NEDO-33922-A
Revision 3
June 2022

BWRX-300 Containment Evaluation Method

ONTARIO POWER GENERATION	
OPG Document Number	
NK054-REP-03555-00001	
OPG Security Classification	
Confidential	
ACCEPTED	
ACCEPTED AS NOTED	x
REVISE AND RESUBMIT	
	March 14, 2024
Signature	Date
Name: Balraj Jassar, Manager	
Dept: Nuclear Safety, Projects, DNNP	
This acceptance does not relieve the contractor from responsibility for errors or omissions or from any obligations or liability under this contract.	
Notes: Refer to the adjacent notes

SUBJECT: FINAL SAFETY EVALUATION FOR GE-HITACHI LICENSING TOPICAL
REPORT NEDC-33922P, REVISION 2, "BWRX-300 CONTAINMENT
EVALUATION METHOD" (DOCKET NO. 99900003)

Figure 5-2: TRACG RPV Nodalization

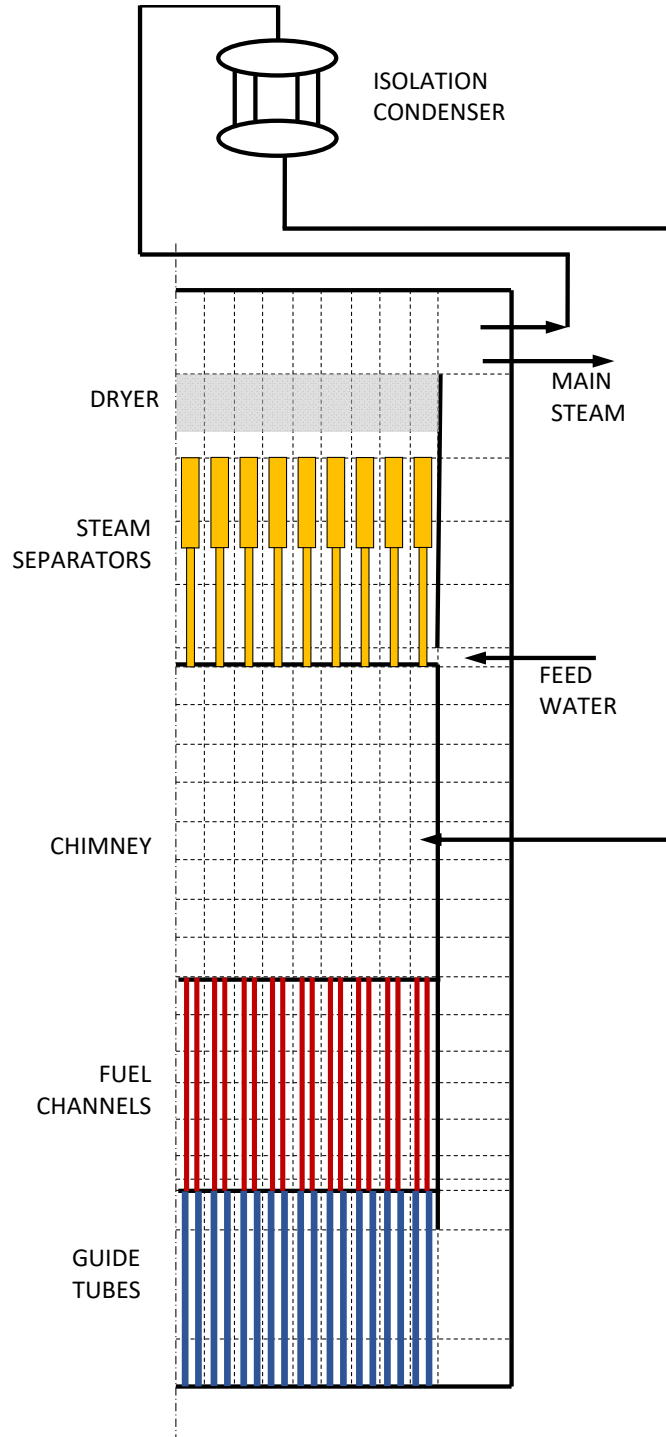
Main feedwater pumps, isolation valves and specific piping segments are used to model inlet piping at the elevation near the top of the chimney as shown in LTR Figure 5-2. [[
